VILLAGE OF GERMANTOWN
N112 W17001 MEQUON ROAD, GERMANTOWN, WI 53022

MEETING:	PLAN COMMISSION
DATE AND TIME:	MONDAY, FEBRUARY 10, 2020 6:30 p.m.
LOCATION:	Germantown Village Hall Board Room

2/10/20 Plan Commission Meeting

Village Planner Report

HAPPY HOLLOW ESTATES
BLOCK 5

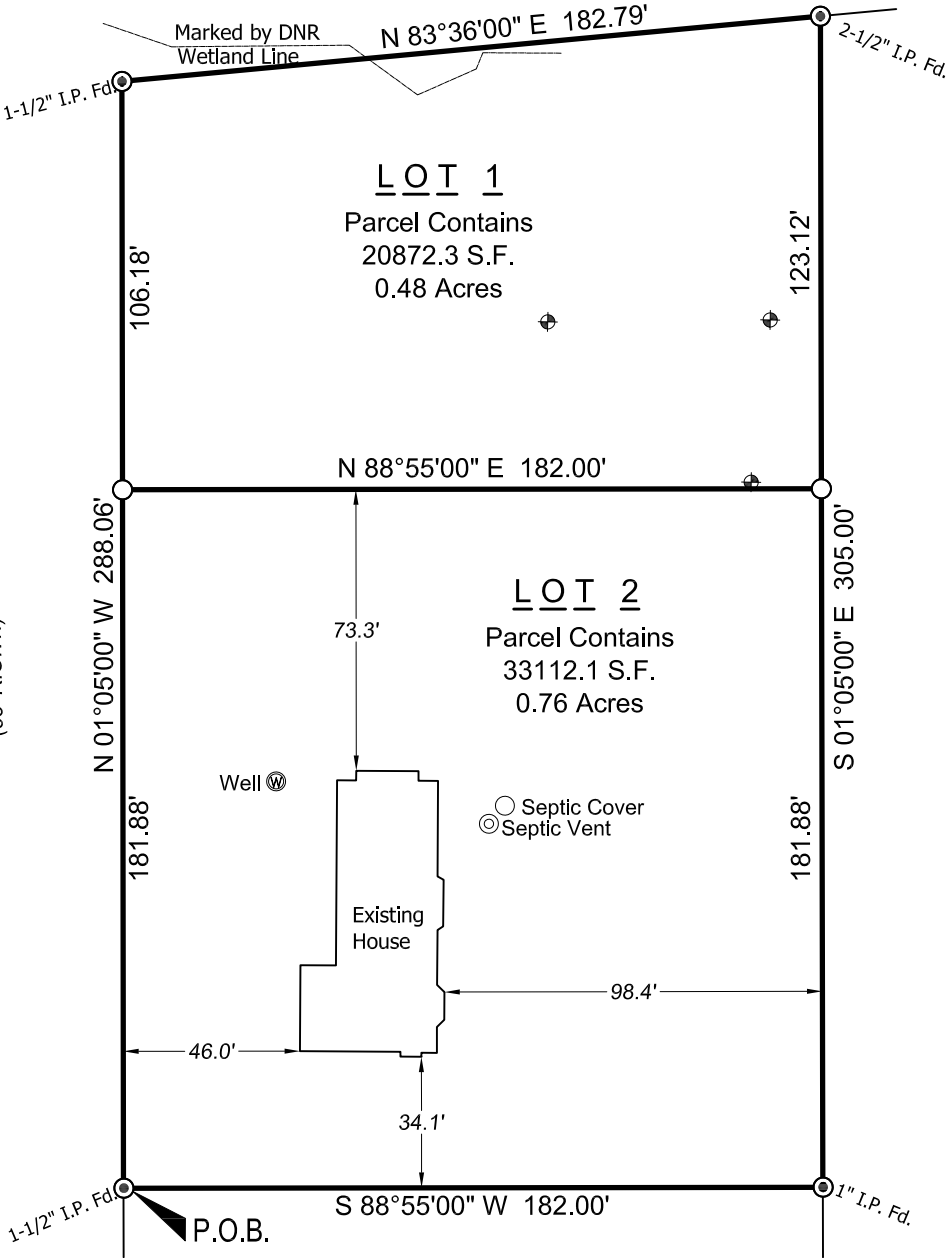
1. Graphically show and dimension building setback lines on all lots per current zoning code.
2. This Certified Survey Map is a redivision of Lot 2 of Block 5 and should be stated as a Redivision on each sheet header, in the Professional Land Surveyor's certificate and in the Village Board's approval certificate
3. The wetland line shown on Lot 1 appears to stop in the middle of the north boundary line, but the documentation supplied by the DNR shows the wetland boundary continuing to the east boundary of the Lot and exiting south of the northeast corner of the Lot.

The question I have is did the DNR not complete the delineation on the property? Did the DNR issue a concurrence or approval letter stating they agreed with the mapping prepared by the surveyor.

4. The 25' wetland setback line needs to be added to the map
5. A certificate of mortgagee is required if the land is mortgaged with a lender. The certificate of mortgagee requires the following information:
 - Complete statements per Chapter 236.21(2)(a)
 - Lending institution name, signature of bank officer and date.
 - Notary statement, seal, signature and date.

6. There is an unnamed stream located in the unimproved right of way of Indian Parkway that needs to be added along with a 75' stream setback from the stream needs to be shown as well.

The mortgage certificate requirement is waived if owner can provide written proof of ownership that the property is free of mortgage from the lending institution.

PLOT PLAN

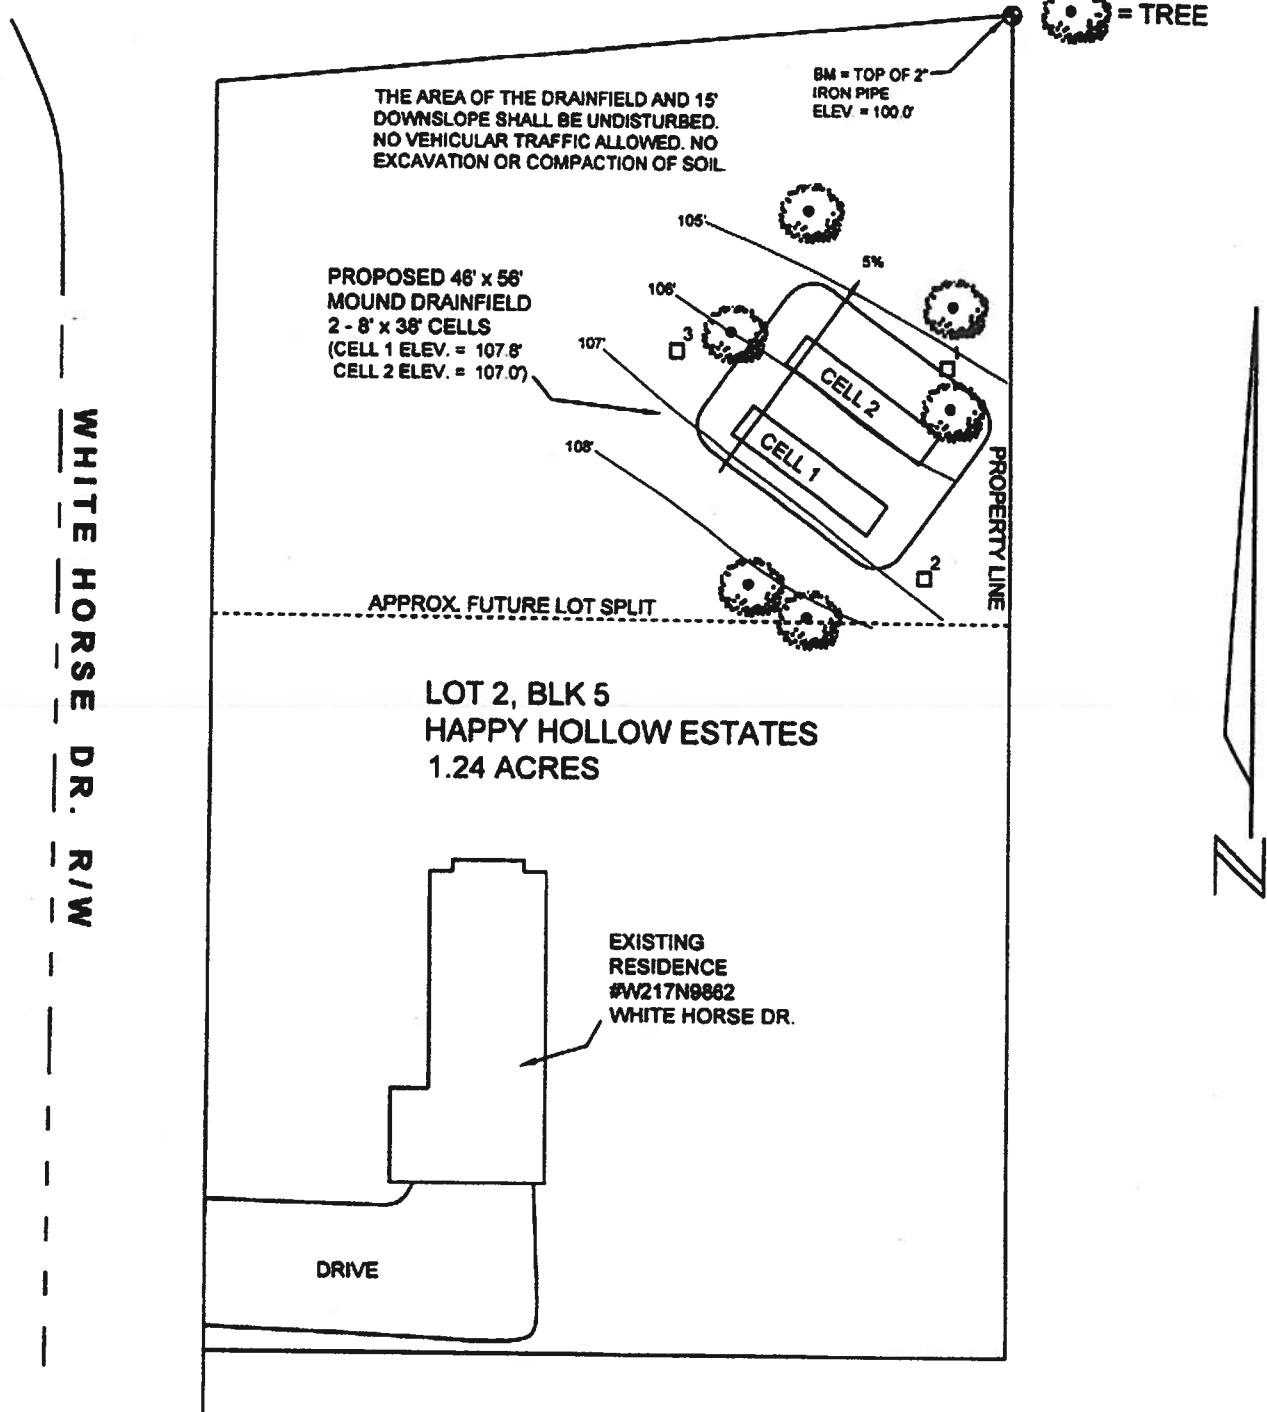
I concur with your detail soil descriptions, site plan and recommendations. Your proposed individual site design of a mound with 12 inches of C-33 sand with a design basal loading rate of .4 gpd/ft² appears feasible. It is assumed that neighboring wells are at least 50 feet away from the proposed mound area.
